# Access Compliance Report

## Public Rights-of-Way

### (Curb Ramps)

Intersection ID: N/A	Main Street: STRAWBERRY_FIELDS_LN	Cross Street: MAGGIE_MAY_LN	Location: S
ADA ID: 1B2E37C47F14	Ramp Type: Perp	Initial Pass/Fail: Fail	Overall Compliance: No
Severity Score: 21.25			
Codes/Mitigation Info/Possible Solution		Field Measurements/Component Compliance

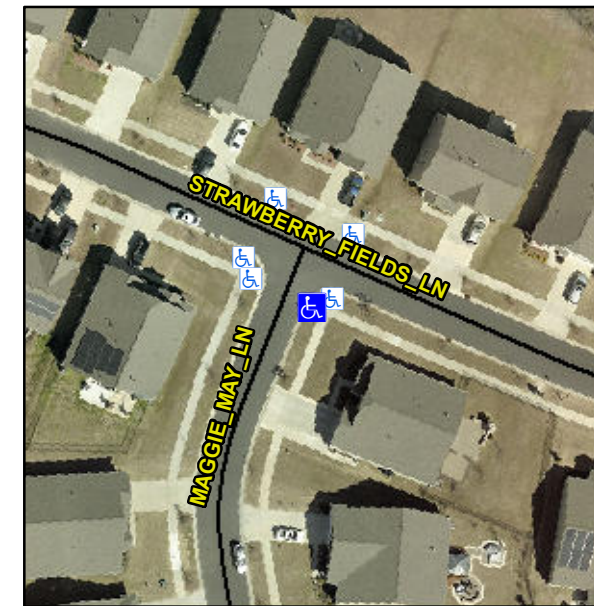
**R304.5.1, R304.2.2**

Compliance	Description	Data	Compliance	Description	Data
N/A	Ramp Length (in)	94.0	No	Ramp Slope (%)	9.9
No	Ramp Width (in)	46.0	Yes	Ramp XSlope (%)	0.4
N/A	Flare Type LT	N/A	N/A	Flare Type RT	N/A
N/A	Flare Slope LT (%)	N/A	N/A	Flare Slope RT (%)	N/A
N/A	Flare Traversable LT?	N/A	N/A	Flare Traversable RT?	N/A
N/A	Landing Length (in)	N/A	N/A	DWS Provided?	N/A
N/A	Landing Width (in)	N/A	N/A	DWS Contrast?	N/A
N/A	Landing Slope (%)	N/A	N/A	DWS Length (in)	N/A
N/A	Landing X Slope (%)	N/A	N/A	DWS Full Width?	N/A
N/A	Landing Curb? (Y/N)	N/A	N/A	DWS Offset (in)	N/A
N/A	Shared Landing?	N/A			
N/A	Gutter Ponding?	N/A	N/A	Gutter Slope (%)	N/A
N/A	Gutter Lip Ht (in)	N/A	N/A	Gutter X Slope (%)	N/A
N/A	Painted X Walk1?	No	N/A	Painted X Walk2?	N/A
	X Walk 1 Direction	To NW		X Walk 2 Direction	N/A
N/A	X Walk 1 Width (in)	N/A	N/A	X Walk 2 Width (in)	N/A
	X Walk 1 Slope (%)	0.5		X Walk 2 Slope (%)	N/A
	X Walk 1 X Slope (%)	1.3		X Walk 2 X Slope (%)	N/A

**Remove & Replace Entire Ramp.**
